**Appeal by Ministry of Justice
Land adjacent to HMP Garth and HMP
Wymott, Leyland Appeal Ref:
APP/D2320/W/22/3295556**

Proof of Evidence of Kevin Riley

on behalf of Chorley Council

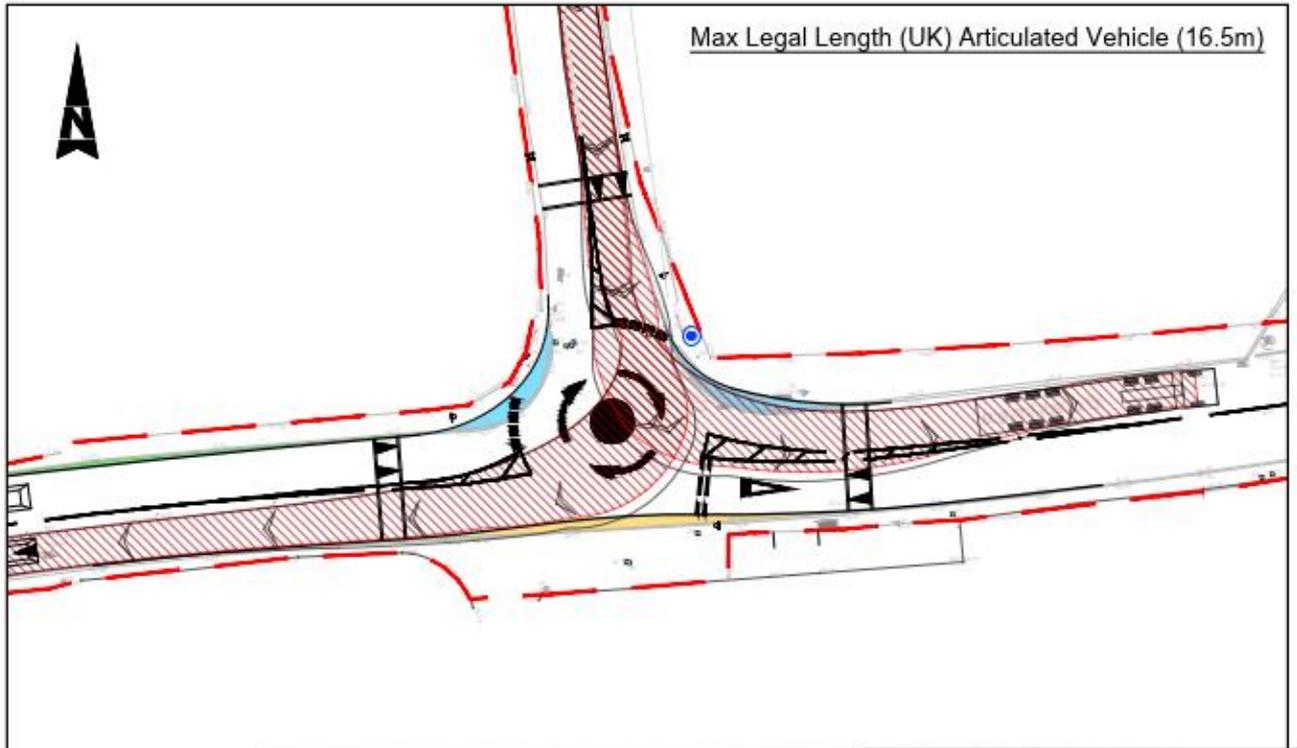
- 5.2.11 The mini roundabout design of the junction (bottom right) cannot be considered a “*betterment*” compared to other solutions. All four plans show the HGV running onto the opposite side of the carriageway, because the road widths and size of the junctions are all similarly constrained by the adopted highway. If a vehicle is on the wrong side of the road, regardless to what extent, it is at risk of being in conflict with another vehicle and that is unsafe. It is simply not a case that any of the layouts above are better than another. They are all unsafe.

- 5.2.12 Whilst this is an existing issue for the existing priority junction (top left), this will be exacerbated by the proposals, not only with more HGVs making the manoeuvre, but also with an increase in other vehicles that could come into conflict with that movement in terms of the cars generated by the development.

- 5.2.13 The only consolation for the existing junction issue, is that currently the vehicles making that manoeuvre must give-way to the main road traffic with the junction being a priority junction, and therefore HGV drivers can try to ensure the road is clear before turning into the path of a potential oncoming vehicle. Although by today’s standard a junction would not be designed as such as it is still not considered safe.

Figure 3.4 Priority junction visibility splays

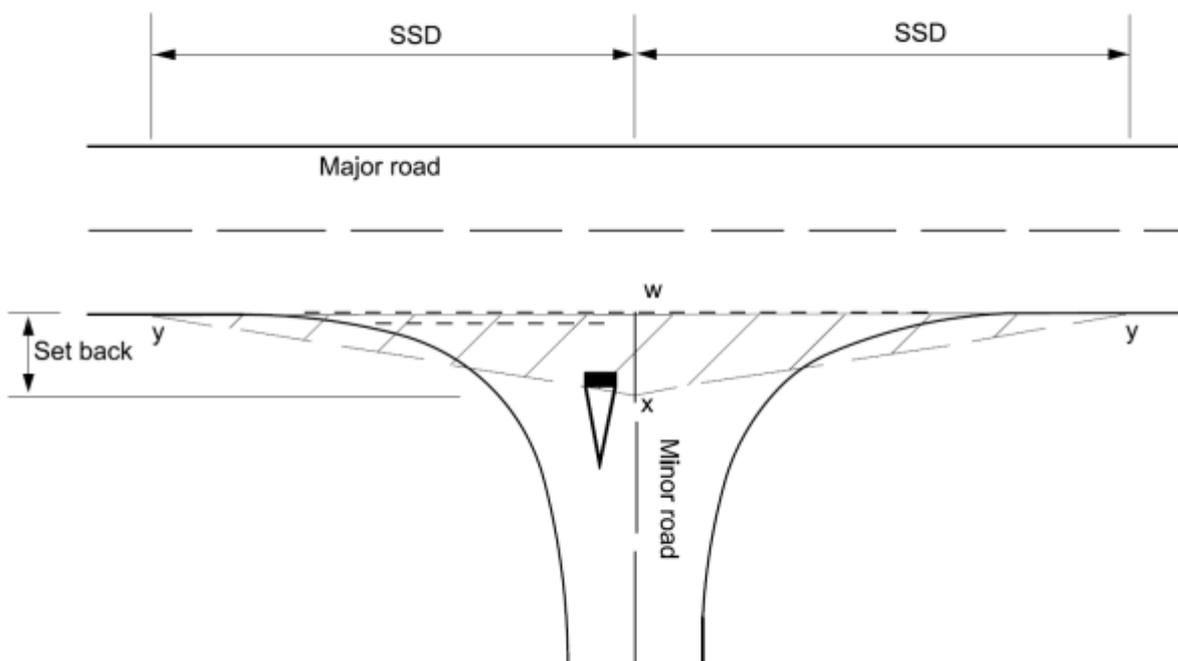
- 5.4.36 The Appellant has incorrectly applied a set back or ‘X’ distance of 9 metres. In quoting the standards in DMRB CD123, the Appellant is referring to section 3.4 to section 3.9 (and including figure 3.4 as shown below).

5.4.37 Section 3.8 part (2) ‘for simple priority junctions’ allows two ‘X’ or set back distances of
 a) 9.0 metres or
 b) 2.4 metres.

5.4.38 Section 3.8 part (3) ‘for all other priority junctions’ allows
 a) 9.0 metres or
 b) 4.5 metres.

- 5.4.46 The recommended ‘X’ distance that should be applied is 2.4 metres, and not the 9.0 metres as quoted by the Appellant.
- 5.4.47 The drawing implies that the standard adopted by the Appellant (which indeed is the wrong one) cannot be achieved within the highway boundary, and instead of the ‘Y’ distance of 90.0 metres in each direction, only 11.5 metres can be achieved to the right and 12.6 metres to the left.

Figure 6-1 - Proposed Construction Routes

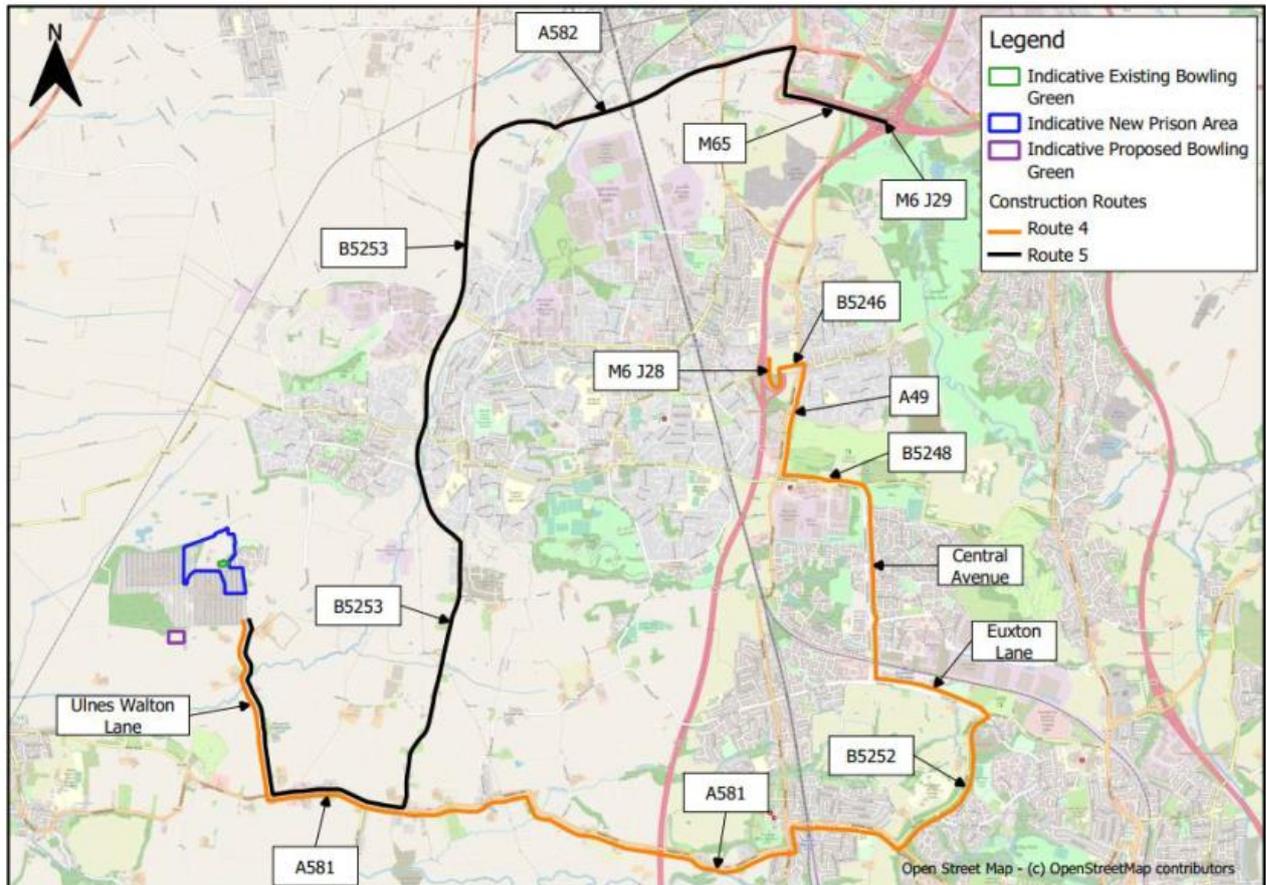
- 6.2.2 All of these vehicles will arrive from the south, turning right into Ulnes Walton Lane at the A581/Ulnes Walton Lane junction, and left into Moss Lane. On departing, all HGVs will travel to the south, turning right at the Moss Lane/Ulnes Walton Lane junction and turning left at the A581/Ulnes Walton Lane junction.

- 6.2.4 According to the Appellant’s traffic figures, in construction there will be a total of 1,350 HGVs one-way (2,700 two-way HGV movements) per month on average over a five-year construction period. This will be a significant increase in HGV traffic on what is largely a rural road and will certainly change the character and its operation during that time.

DRAWING No: 7769-WSP-SK-014	REV: P01
--------------------------------	-------------

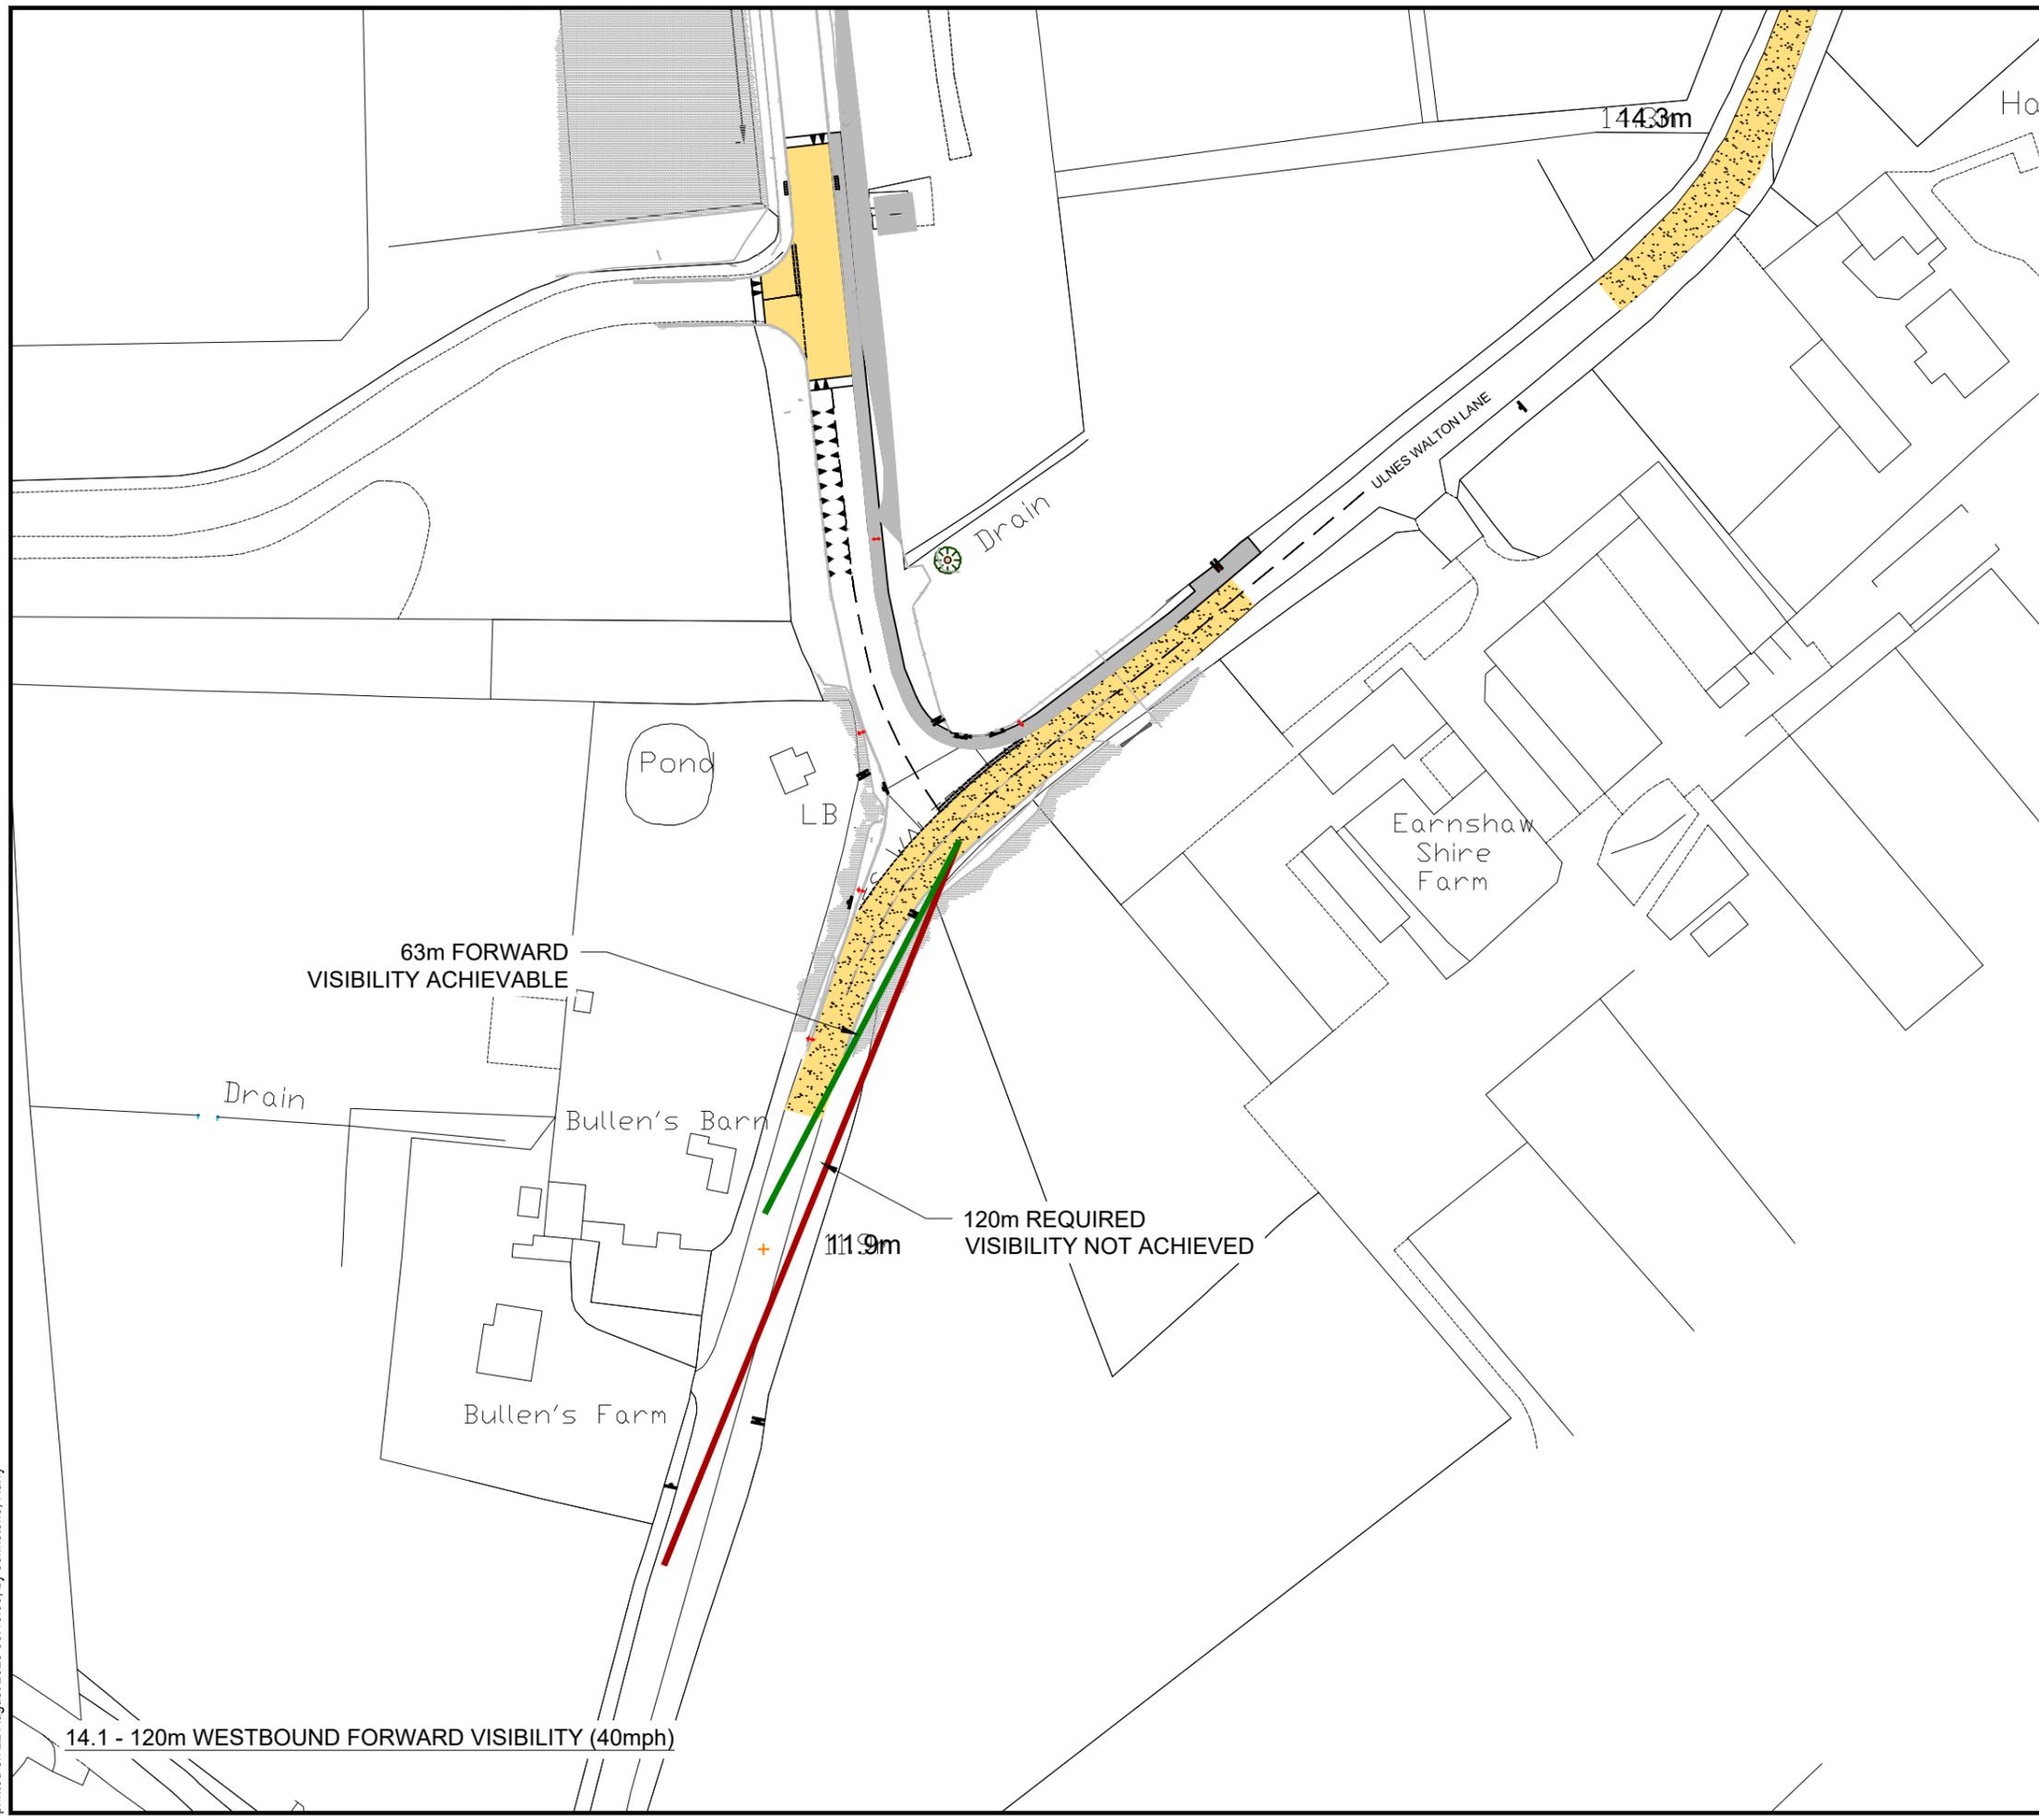
- 2.1.17 Whilst the required SSD is 120 metres, the achievable SSD is 63 metres, as illustrated on 7769-WSP-SK-014 in Appendix A of this Proof. This also is dependent on hedgerows being regularly maintained, which as I set out and evidenced at the previous Inquiry is not the case. I refer to the photographs in the appendix to my original Proof (F1).

- 2.1.18 Whilst this is an existing issue, this will be exacerbated by the proposed development during both construction and operation, with more traffic right-turning into Moss Lane, as well as more traffic opposing this movement arriving from the south and therefore will increase the risk of vehicle-vehicle conflict. This has simply not been addressed.
